FINAL REPORT

SNOWDRIFT ASSESSMENT PROPOSED WASTEWATER LAGOON CLYDE RIVER, NUNAVUT

Project Number: 08-1023

February 29, 2008

LEGEND

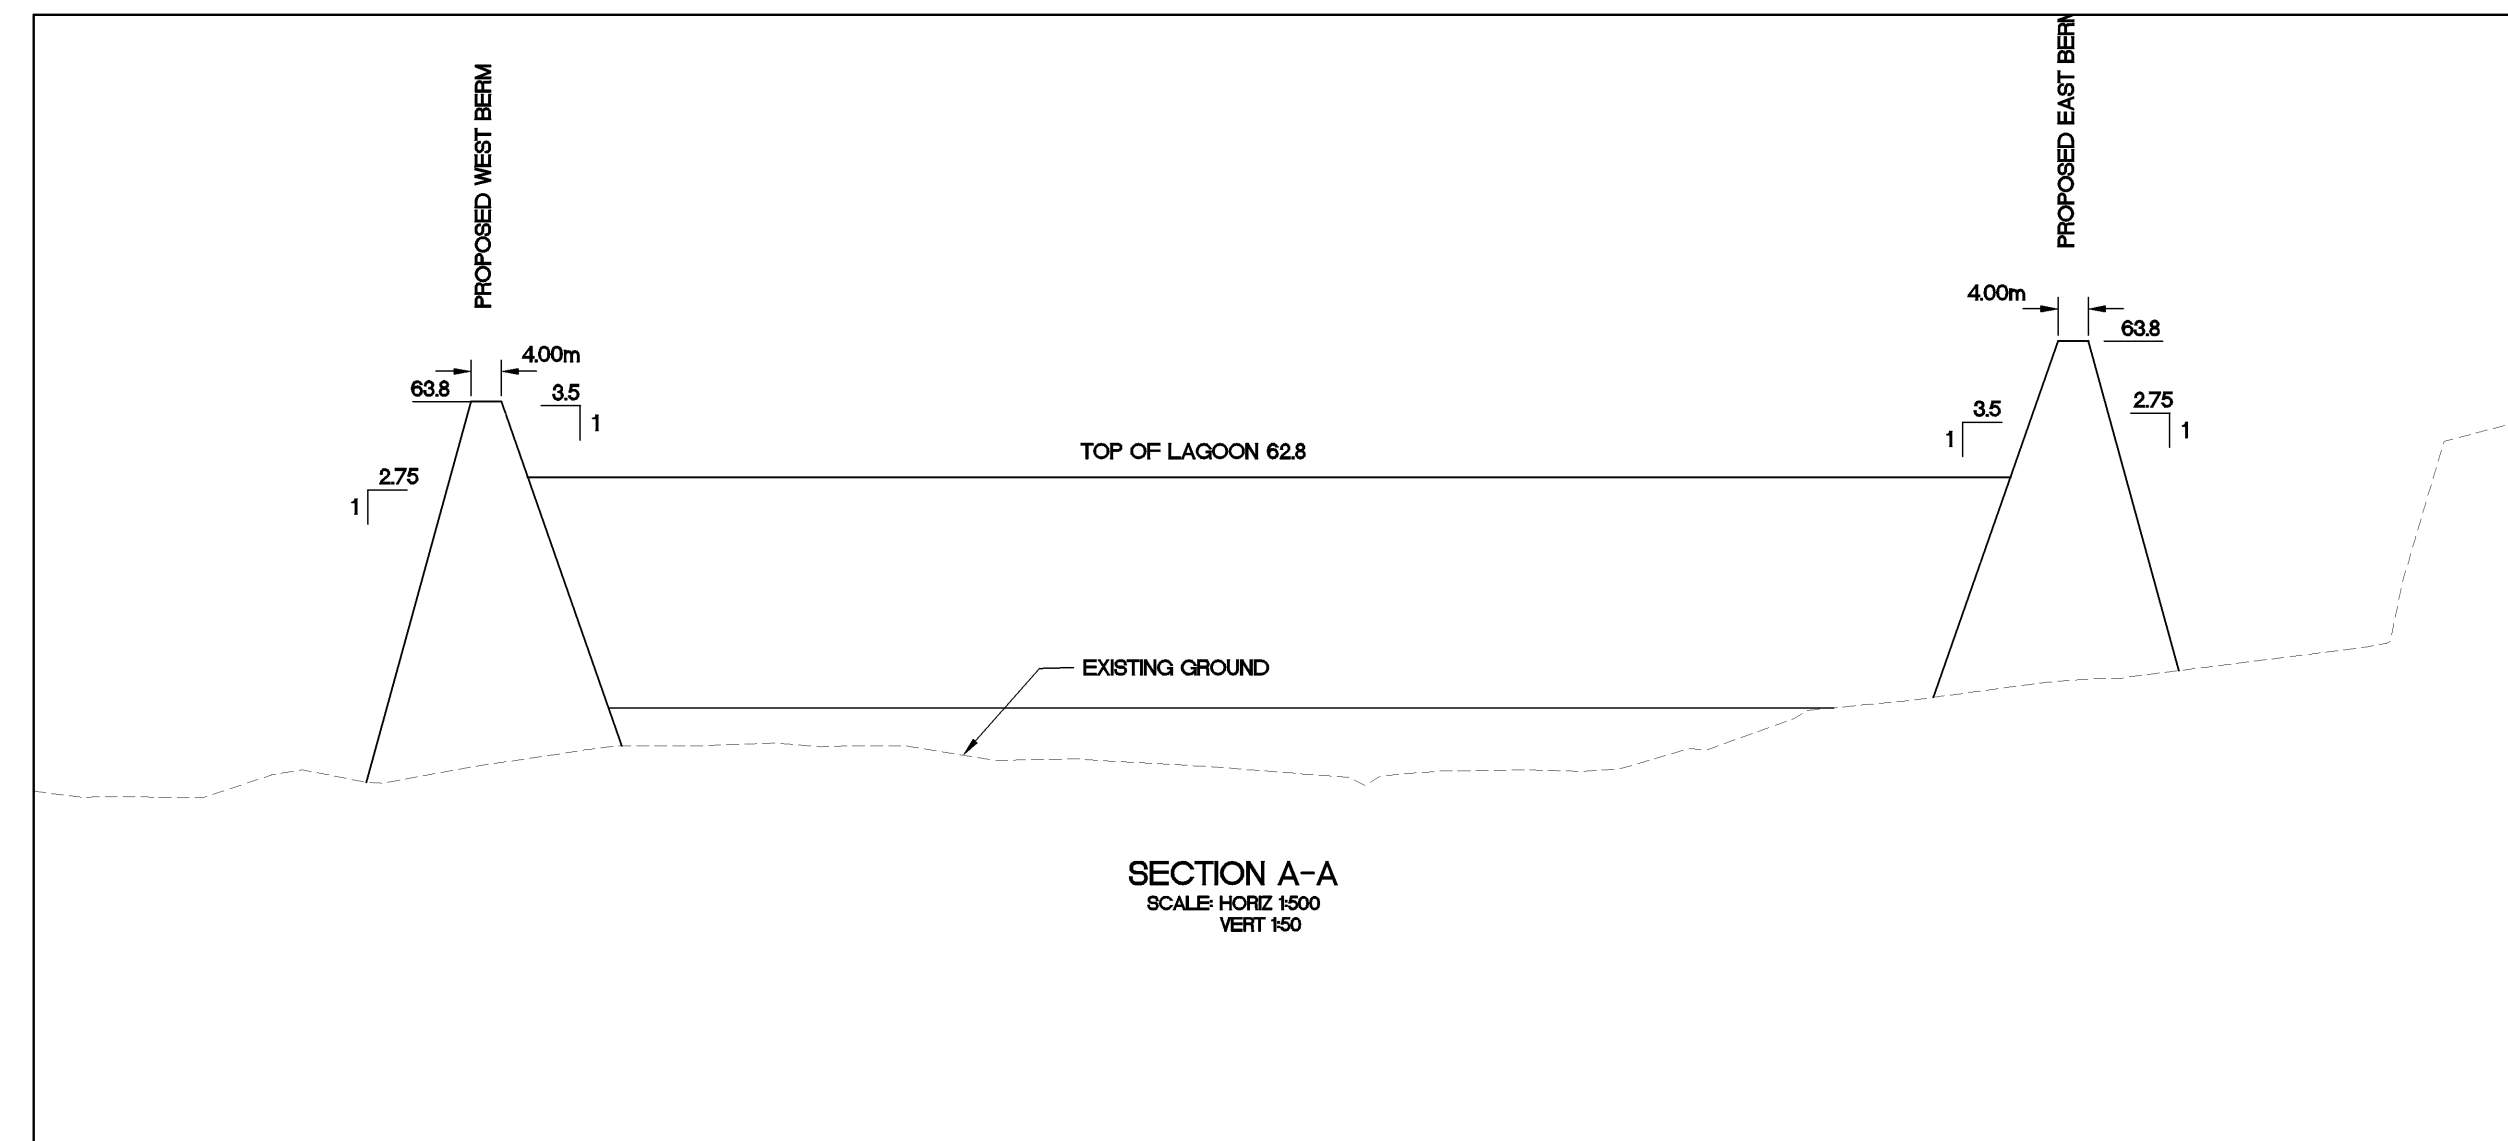
The main difference between Alternatives 3 and 4 is the presence of a second discharge point near the northwest "corner" of the existing lagoon in Alternative 4. The layout of the discharge area at the southeast "corner" of the existing lagoon is no different than the previous scheme we had reviewed, as per our final report you currently have. Those report comments would stand. The "northwest" discharge area is on the windward side of the lagoon. The safety barriers (e.g., boulders) are on the downwind (southeasterly) thus drifting on the traveled surface of the discharge area would be minimal.
